Technical Memorandum

Ref: 16-002518-WTM02-Rev3

Subject: Covella - Water Precinct Network Plan Amendments

Covella - Water Precinct Network Plan Amendments

Attachment 3: Offset Works Plan Drawing No. 15-003700-SK01

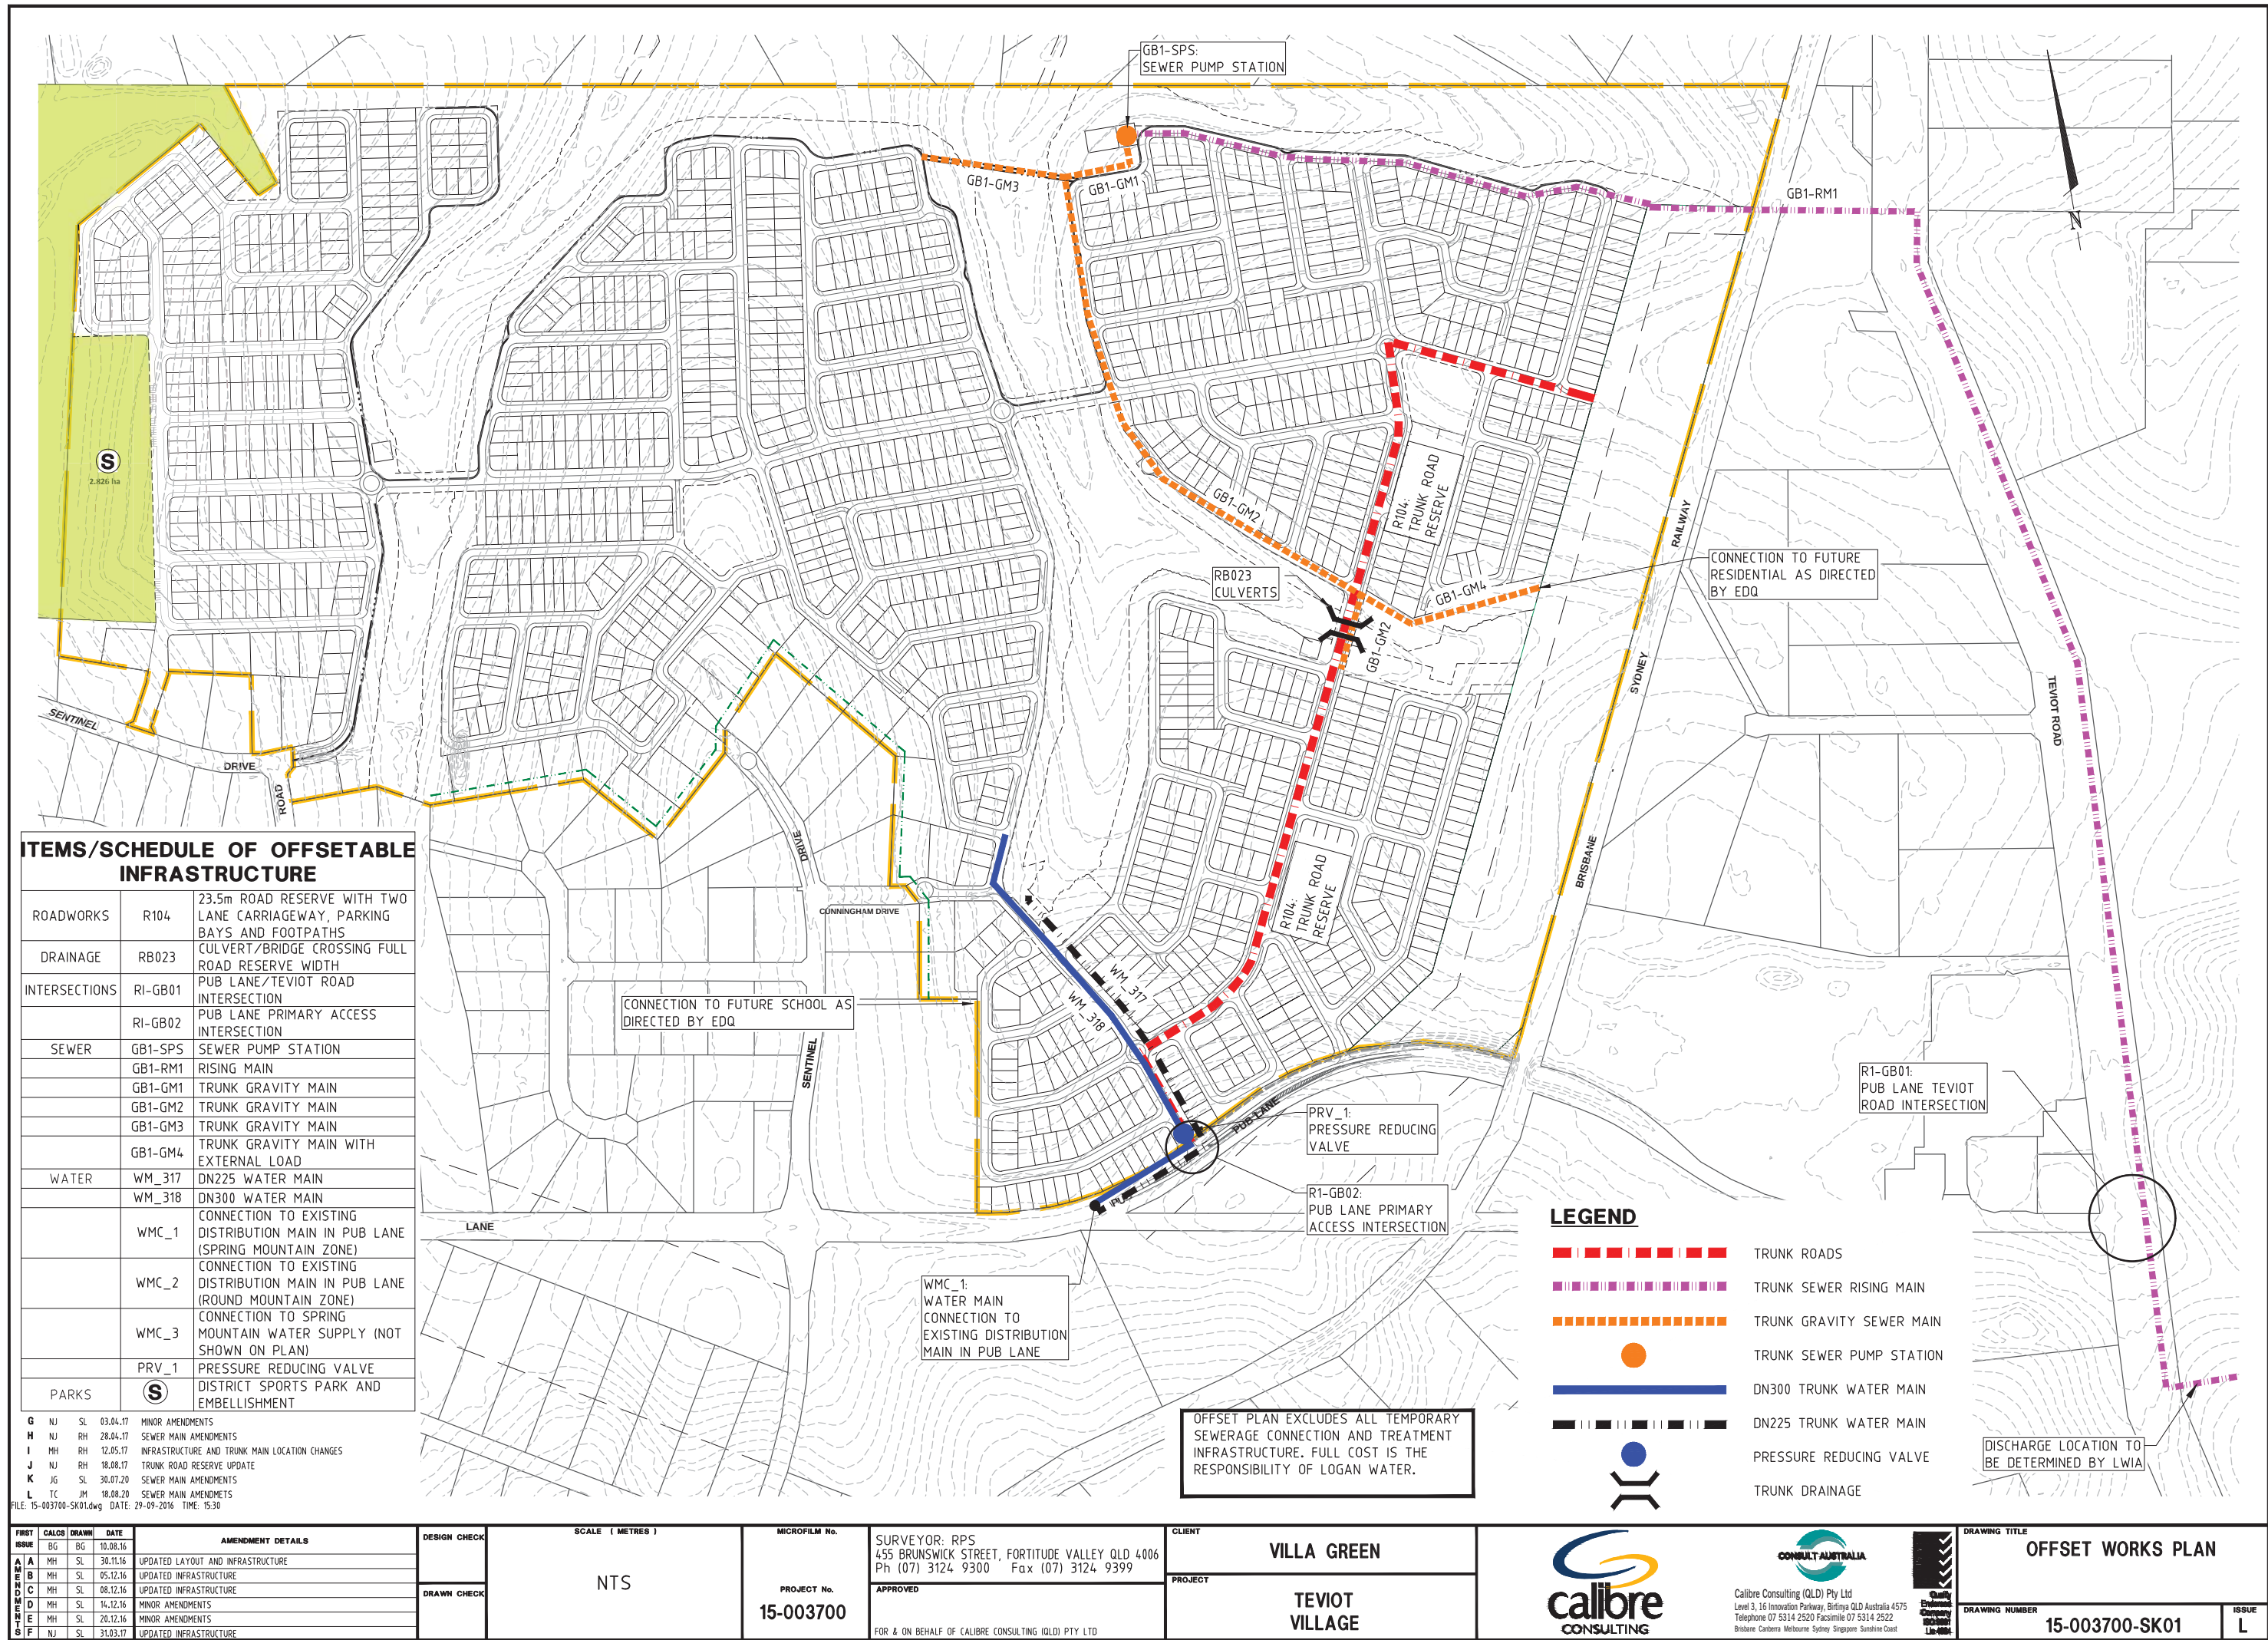
- EDQ and Logan Water endorse the proposed internal water servicing amendment outlined within this memo and update Offset Works in accordance with Drawing No. 15-003700-SK01 within Attachment 3.
- Adopt the revised water network configuration in accordance with amended drawings included within Attachment 1 & 2.
- Verify network boundary conditions and confirm modelling assumptions prior to further detailed design.
